TDECQ conformance test setup, reference receiver and exceptions in 802.3ds

Supporting comments: #23,24,25

Guangcan Mi
Huawei

IEEE P802.3ds TF meeting
July 13, 2026

Figure 180–9—TDECQ conformance test block diagram

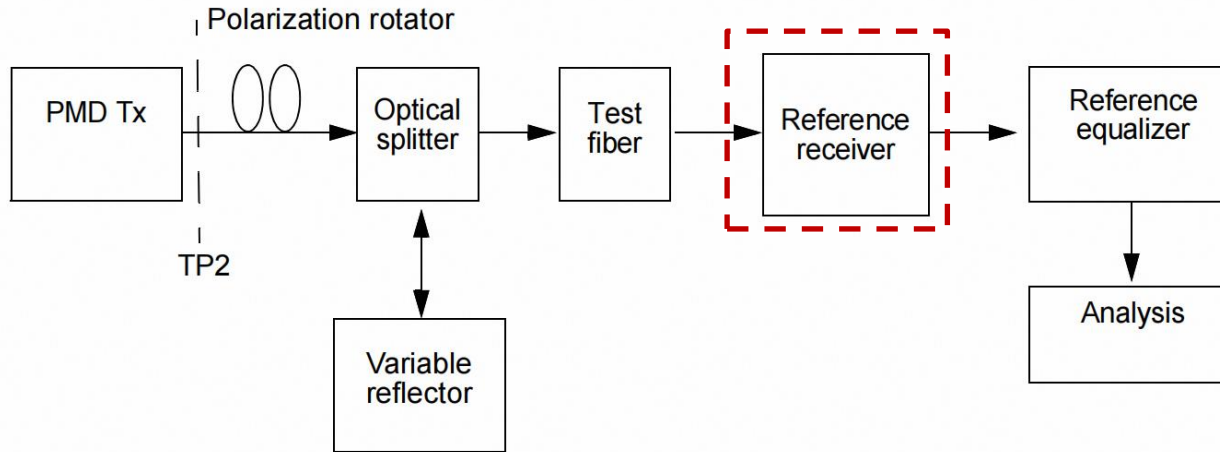
Current text in 802.3ds for TDECQ has some ambiguity

- The TDECQ of each lane shall be within the limit given in Table 193–7 if measured using the methods specified in 180.9.6, with the following exceptions:

- The conformance test block diagram shown in Figure 167–4 is used in place of Figure 180–9.
 - The frequency response of the combination of the O/E converter and the oscilloscope used to measure the optical waveform is that of two cascaded filters. The first filter emulates the dispersion of the fiber and has a 3 dB bandwidth f_A that depends on the PMD type and the center wavelength of the transmitter according to Table 193–14. The fourth-order Bessel-Thomson response of the first filter should extend to at least $2.6 \times f_A$ GHz, and at frequencies above $2.6 \times f_A$ GHz, the response should not exceed –20 dB. The second filter represents the reference equalizer front end and is described in 193.9.3. O/E-3

- O/E-1 $\neq$ O/E-2 $\neq$ O/E-3
- Multiple bandwidths or frequency responses were mentioned, and some are related
- 193.9.3 is the reference receiver, not the reference equalizer front end. The reference equalizer, defined in 193.7.1 and referenced in the text, is the multi-tap filter, does not have a front end.

Proposed change :

The conformance test block diagram shown in Figure 193-10 is used in place of Figure 180–9

Figure 180–7—Reference receiver block diagram

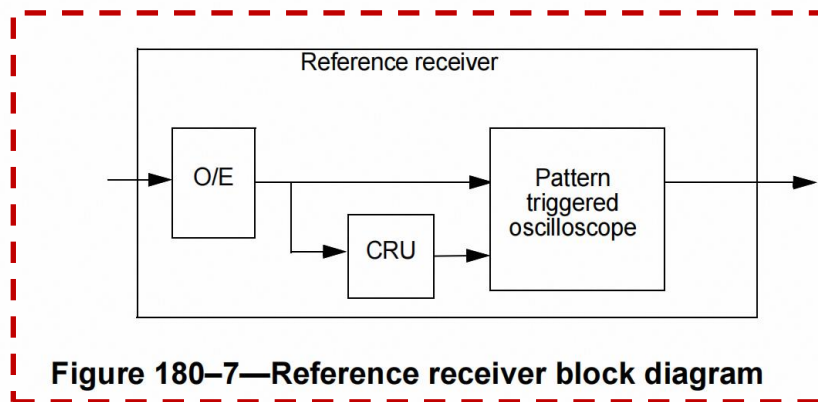
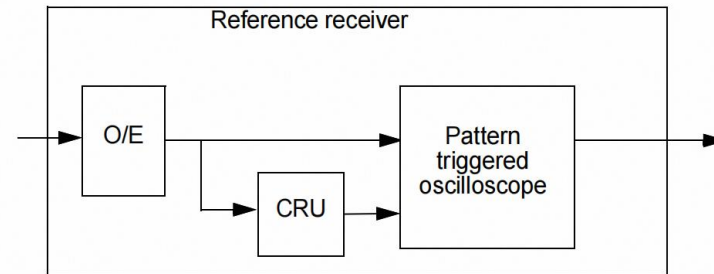
Current text in 802.3ds for reference receiver

- A reference receiver is defined for transmitter measurements. The reference receiver, composed of the combination of the O/E converter and the oscilloscope, has a 3 dB bandwidth of approximately 53.125 GHz with a fourth-order Bessel-Thomson response to at least 1.3×106.25 GHz. At frequencies above 1.3×106.25 GHz, the reference receiver response should not exceed -20 dB. Compensation may be made for any deviation from an ideal fourth-order Bessel-Thomson response. The clock recovery unit (CRU) has a corner frequency of 4 MHz and a slope of 20 dB/decade. The CRU may be implemented in hardware or software depending on oscilloscope technology.

Its block diagram would look like this
